**MADERA UNIFIED  
SCHOOL DISTRICT**  
1902 Howard Road  
Madera CA 93637  
(559) 675-4500  
(559) 675-1186 Fax  
[www.madera.k12.ca.us](http://www.madera.k12.ca.us)

Addendum No. 1-Bid Section 1-5  
Asphalt Resurface & Repairs at Various School Sites  
BID No. 033116

This Addendum is attached to and made a part of the above entitled specifications for Madera Unified School District for BID No. 033116 with a due date of May 5, 2016

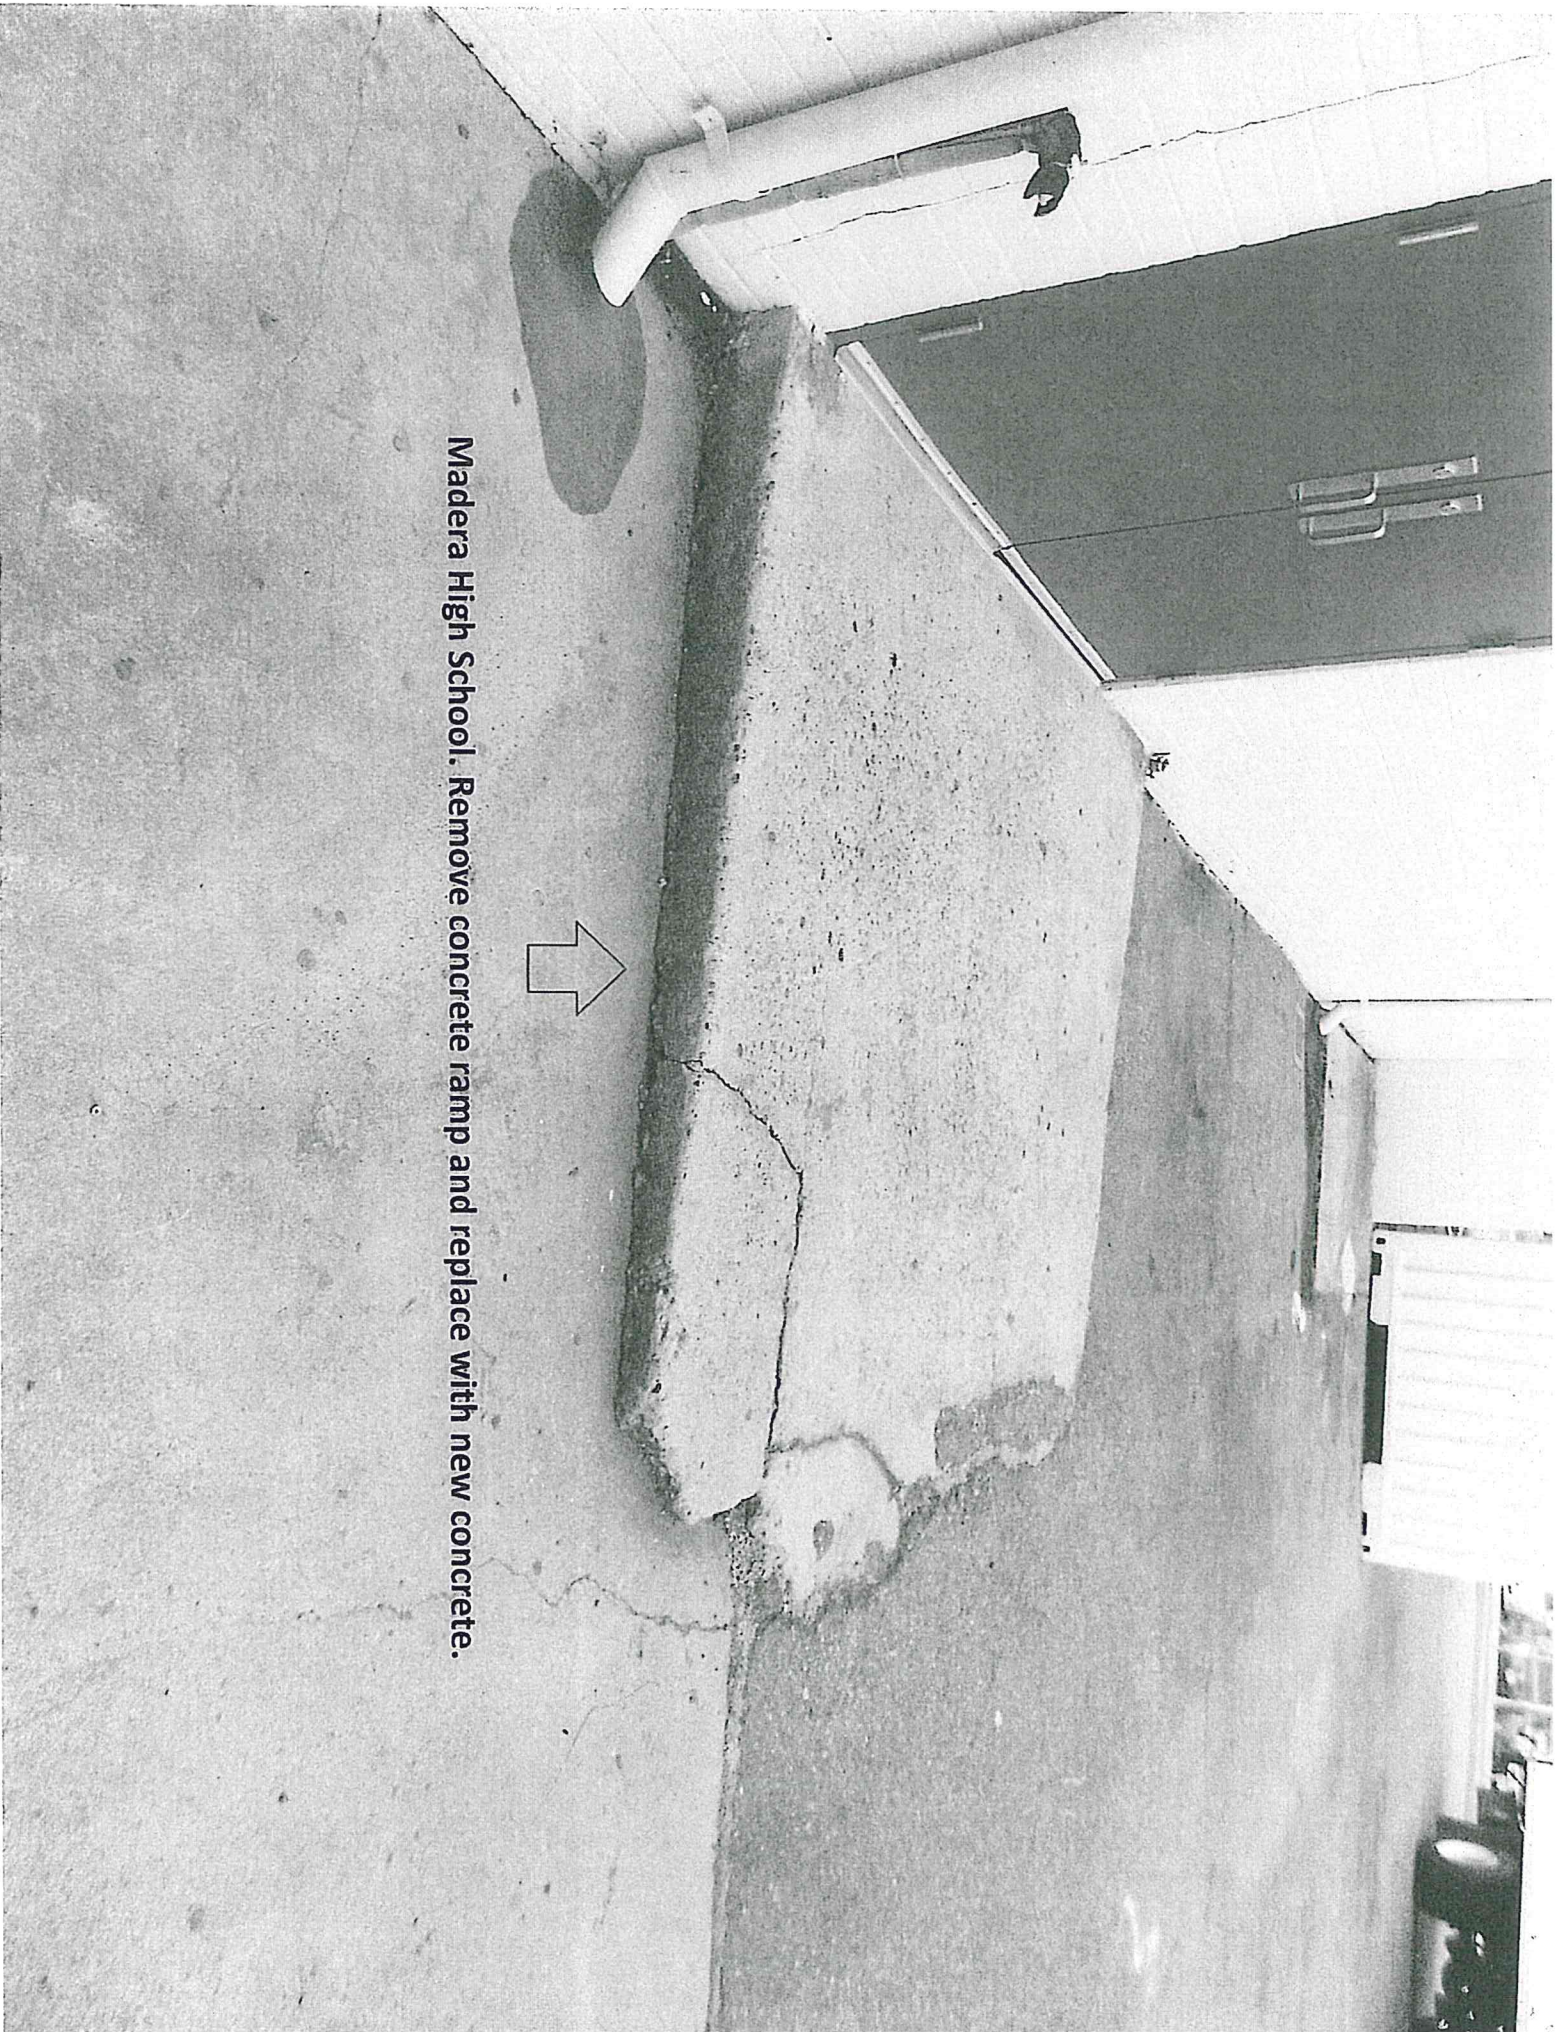
**Madera High School. Concrete removal  
start point. Typical of both sides**

**Madera High School concrete gutter removal  
start point. Typical both sides.**

**Madera High School. Remove concrete gutter where existing asphalt starts and replace with asphalt**

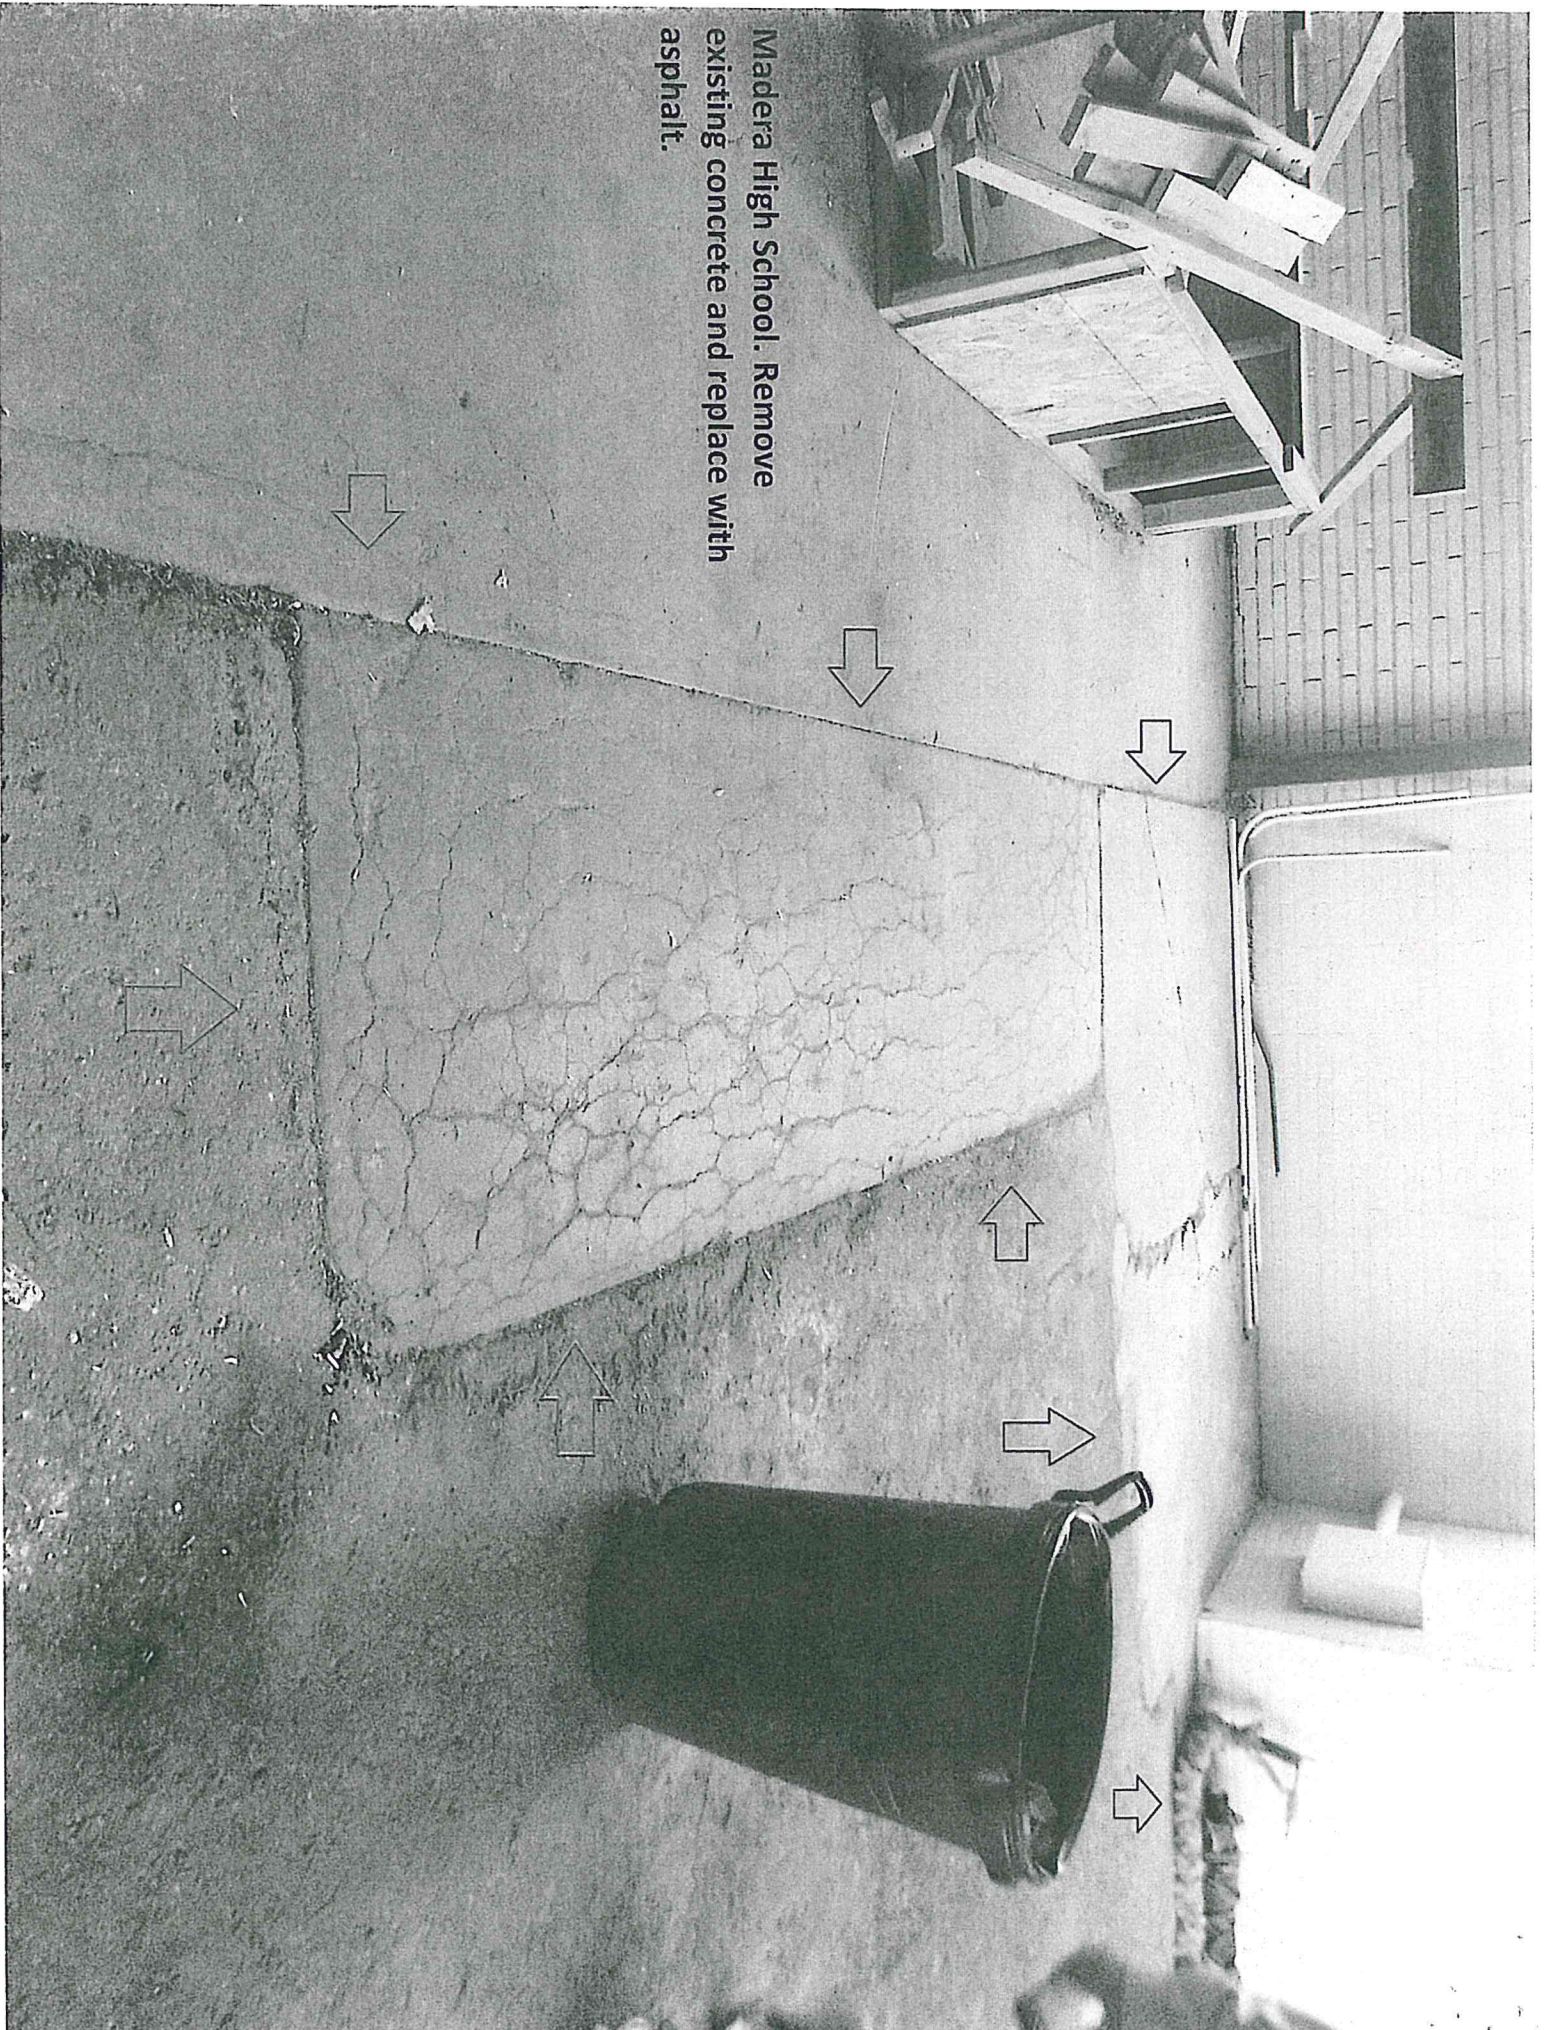
Madera High School. Remove concrete ramp and replace with new concrete.
